ADDENDUM NO. 1
DATE: December 27, 2011

Contract 12-C-00005; Horatio Street Sewer Replacement

W.O. 5336
SHEET
4
OF 10

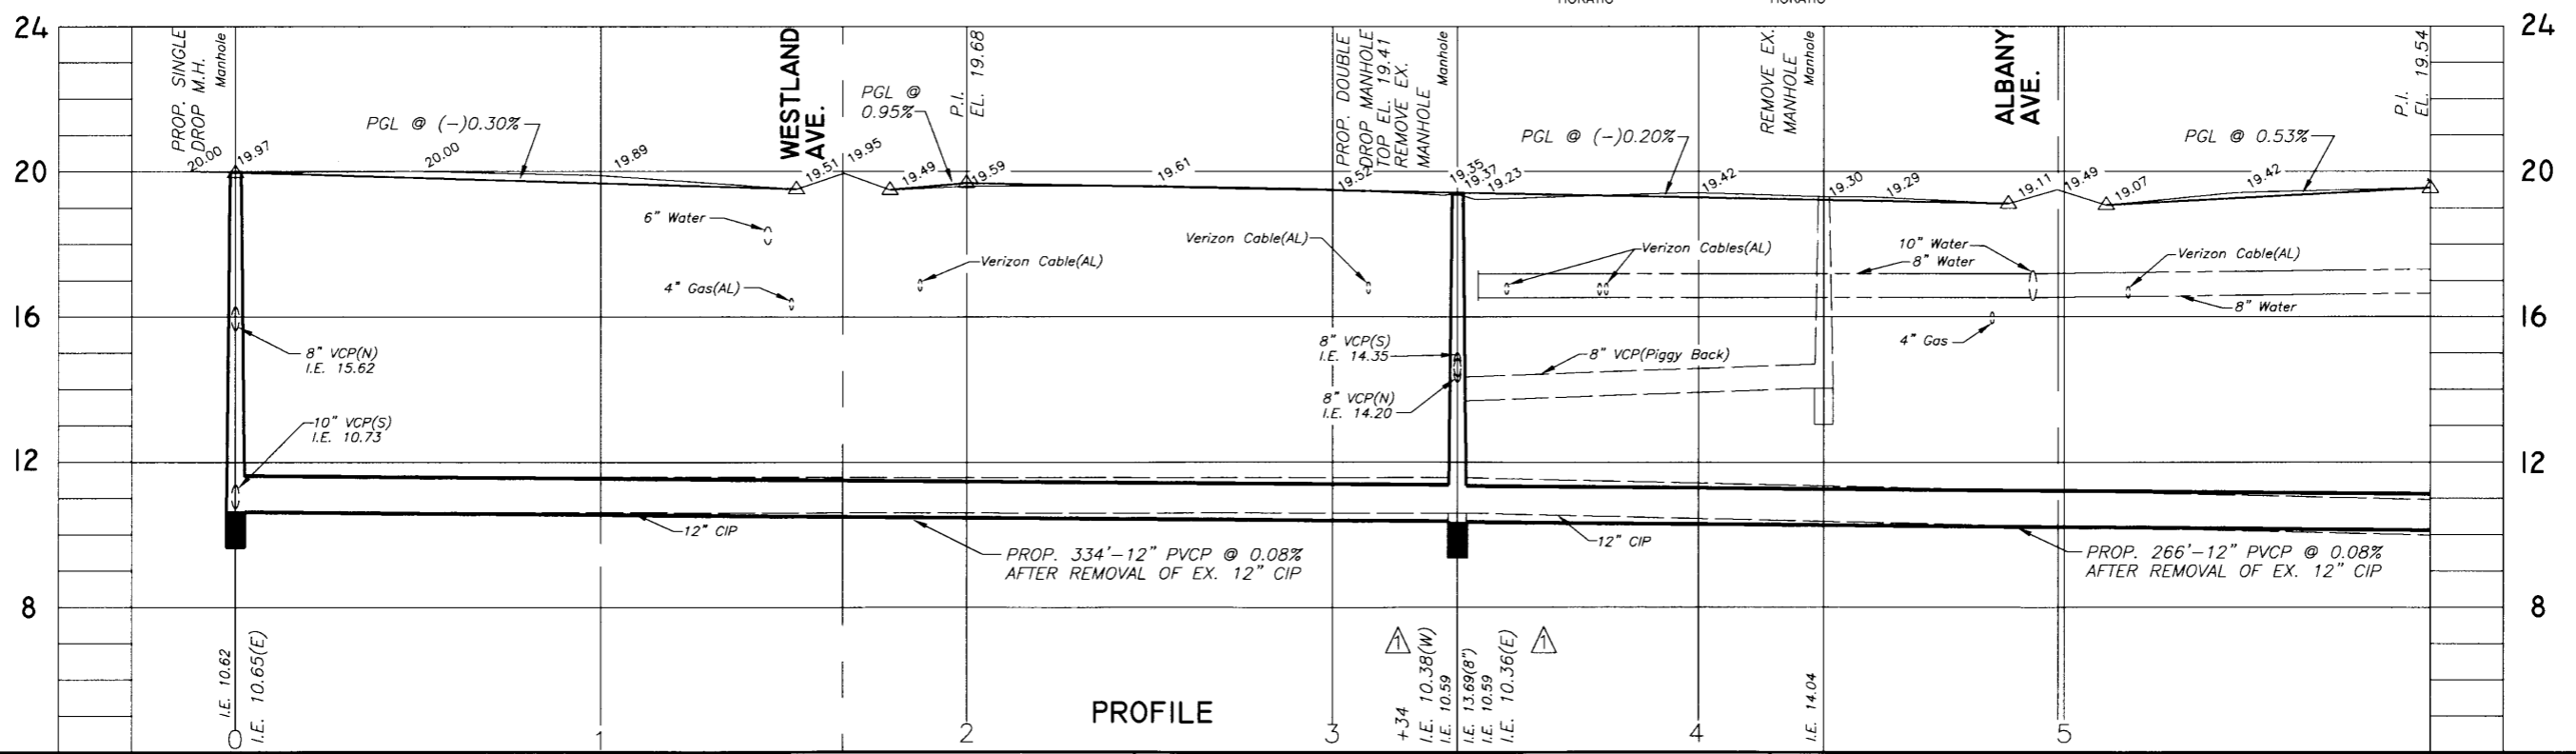
REPLACE sheets 4 and 5 with the attached revised sheets 4 and 5.

No.	DATE	REVISIONS
3		
2		
▲	12/27/11	ADDED MANHOLE & CHANGED INVERT EL.

W.O. 5336
SHEET
5
OF 10

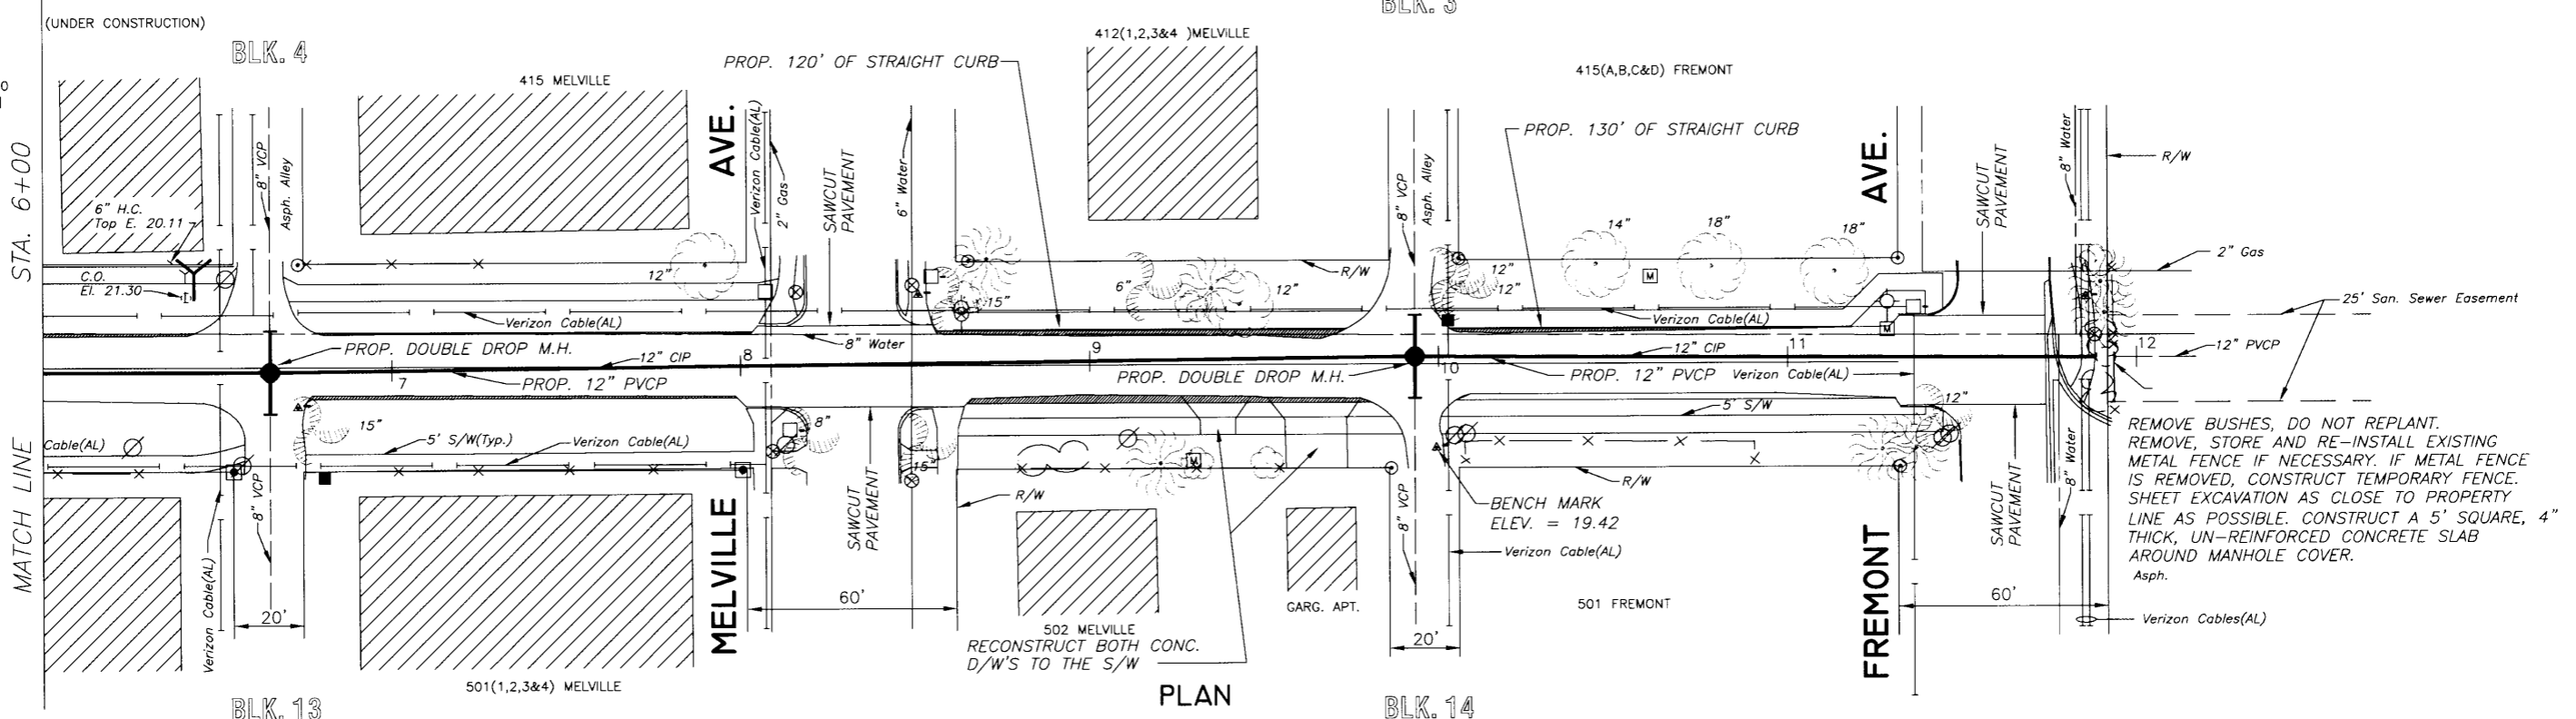
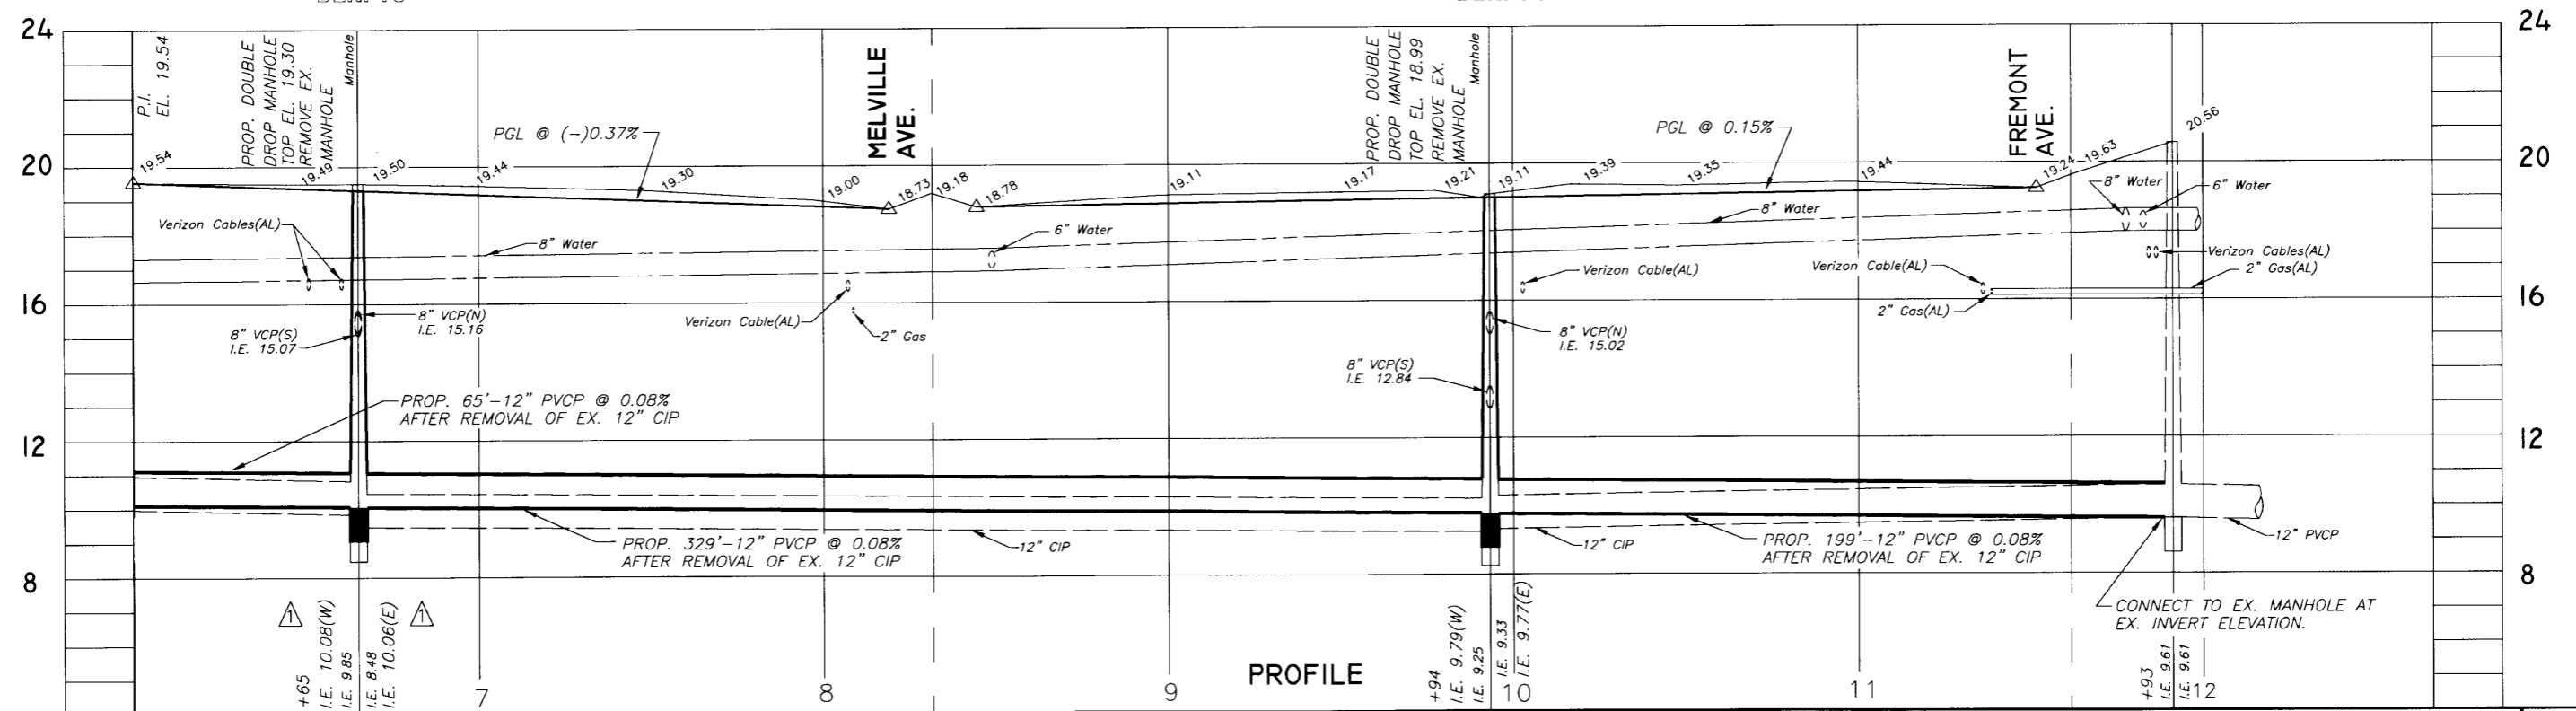
No.	DATE	REVISIONS
3		
2		
▲	12/27/11	CHANGED INVERT EL.
